# Access Compliance Report

## Public Rights-of-Way

### (Curb Ramps)

Intersection ID: 30200	Main Street: BIESTERFIELD_DR	Cross Street: SLATER_SPRINGS_DR	Location: NW
ADA ID: F29ADB370971	Ramp Type: Perp	Initial Pass/Fail: Fail	Overall Compliance: No
		Severity Score: 10

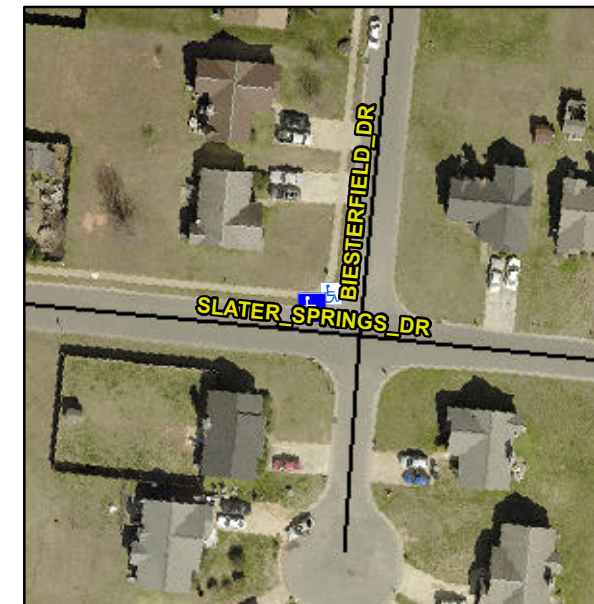
**Not Found, R304.5.1, R304.5.3**

Compliance	Description	Data	Compliance	Description	Data
N/A	Ramp Length (in)	50.0	Yes	Ramp Slope (%)	6.3
No	Ramp Width (in)	42.5	No	Ramp XSlope (%)	4.0
N/A	Flare Type LT	N/A	N/A	Flare Type RT	N/A
N/A	Flare Slope LT (%)	N/A	N/A	Flare Slope RT (%)	N/A
N/A	Flare Traversable LT?	N/A	N/A	Flare Traversable RT?	N/A
N/A	Landing Length (in)	N/A	N/A	DWS Provided?	N/A
N/A	Landing Width (in)	N/A	N/A	DWS Contrast?	N/A
N/A	Landing Slope (%)	N/A	N/A	DWS Length (in)	N/A
N/A	Landing X Slope (%)	N/A	N/A	DWS Full Width?	N/A
N/A	Landing Curb? (Y/N)	N/A	N/A	DWS Offset (in)	N/A
N/A	Shared Landing?	N/A			
N/A	Gutter Ponding?	N/A	N/A	Gutter Slope (%)	N/A
N/A	Gutter Lip Ht (in)	N/A	N/A	Gutter X Slope (%)	N/A
N/A	Painted X Walk1?	No	N/A	Painted X Walk2?	N/A
	X Walk 1 Direction	To S		X Walk 2 Direction	N/A
N/A	X Walk 1 Width (in)	N/A	N/A	X Walk 2 Width (in)	N/A
	X Walk 1 Slope (%)	1.4		X Walk 2 Slope (%)	N/A
	X Walk 1 X Slope (%)	2.1		X Walk 2 X Slope (%)	N/A

**Remove & Replace Entire Ramp.**
